City of Sugar Hill
Planning Staff Report
CBD Design Review 20-00520

DATE: July 1, 2020
TO: Mayor and Council, Design Review Board
FROM: Planning Director
SUBJECT: Central Business District (CBD) Design Review
4888 Roosevelt Circle

CITY OF SUGAR HILL
 CONCEPT PLAN FOR:
4888 ROOSEVELT CIRCLE

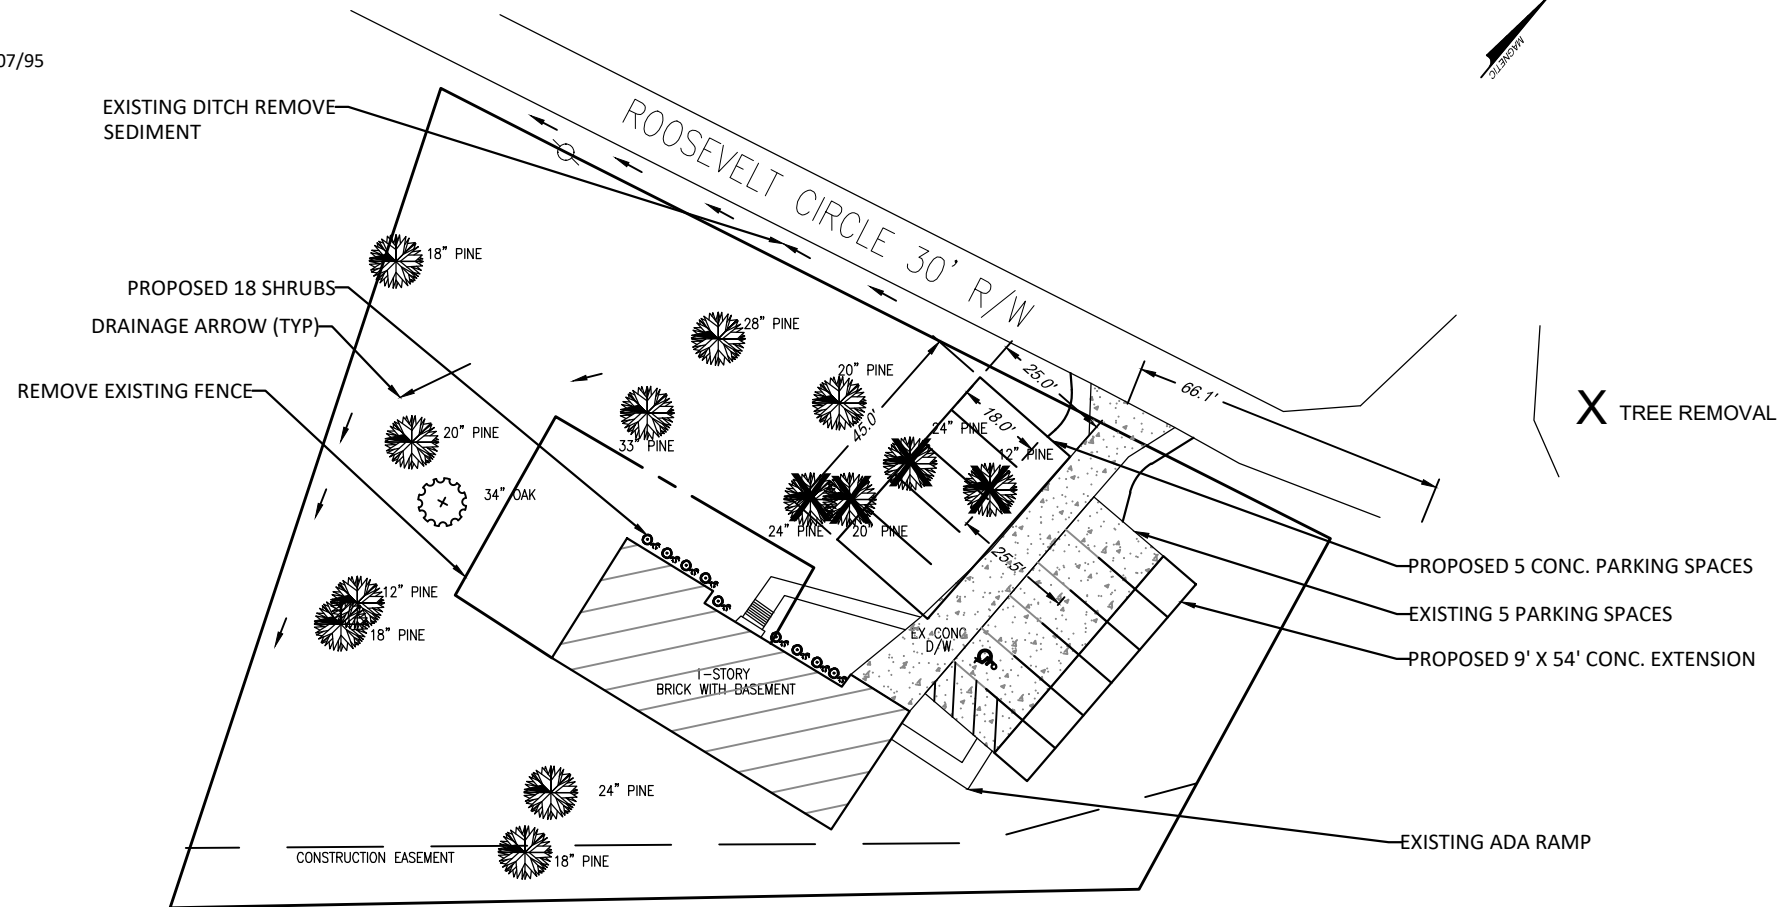
The proposed design is consistent with the adopted design guidelines.

The proposed designs are consistent with the emerging nature of the area being developed under the Central Business District Overlay.

Yes. The applicant is proposing to clean up and repaint the existing buildings. The proposed improvements will enhance the visual appeal of the property and remain consistent with the surrounding businesses.

No. The proposed changes do not contribute to any of the listed inappropriate design criteria.

Approval the design concept in material and architectural detail as shown on the attached Exhibits 1 and 2.
